HAMPTON PARK SUBDIVISION

APPLICATION NUMBER 11 DATE July 20, 2006

REQUEST Subdivision

DETAIL SITE PLAN

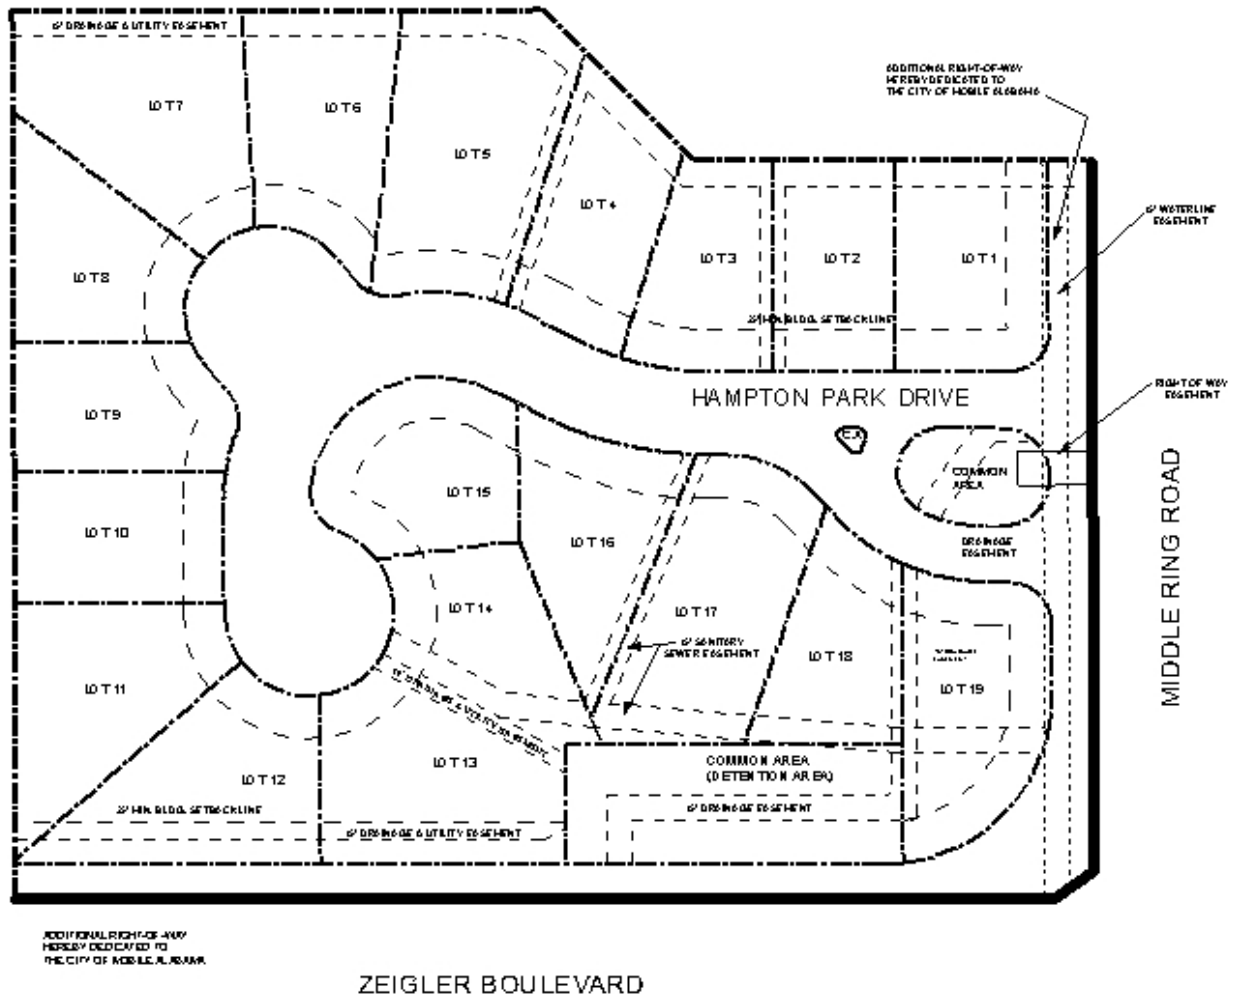
The site fronts Zeigler Boulevard and Middle Ring Road, both of which are planned major streets, and as such require 100-foot rights-of-way. As shown on the preliminary plat, the final plat should show the existing rights-of-way, and dedication of sufficient right-of-way to provide 50 feet from the centerlines of Zeigler Boulevard and Middle Ring Road (excluding service roads). Furthermore, direct access to Zeigler Boulevard and Middle Ring Road should be denied for Lots 1, 11, 12, 13, and 19.

As the site involves the creation of new streets, construction and dedication to City Engineering standards will be required. The plat shows common and detention areas, and the required note assigning responsibility for their maintenance to the property owners. However, the plat should be modified to provide access to the common detention area from the subdivision streets, rather than from Zeigler Boulevard.

The plat meets the minimum requirements of the Subdivision Regulations and is recommended for Tentative Approval, subject to the following conditions: 1) compliance with Engineering comments (No drainage patterns were shown as required by the Subdivision Regulations, therefore, a thorough evaluation of drainage concerns could not be completed. A Hold Harmless agreement will be required if stormwater runoff is increased and/or concentrated onto an

adjacent property. Must comply with all stormwater and flood control ordinances. Any work performed in the right of way will require a right of way permit. The applicant is responsible for verifying if the site contains wetlands. If the site is included on the NWI, it is the applicant's responsibility to confirm or deny the existence of regulatory wetlands.); 2) revision of the plat to provide access to common detention areas from the subdivision streets, rather than Zeigler Boulevard; 3) dedication of sufficient right-of-way to provide 50 feet from the centerlines of Zeigler Boulevard and Middle Ring Road, as shown on the preliminary plat; 4) construction and dedication of the new streets to City Engineering standards; 5) the placement of a note on the final plat stating that direct access to Zeigler Boulevard and Middle Ring Road is denied to Lots 1, 11, 12, 13, and 19; and 6) the placement of a note on the final plat stating that maintenance of common areas will be property owners' responsibility.
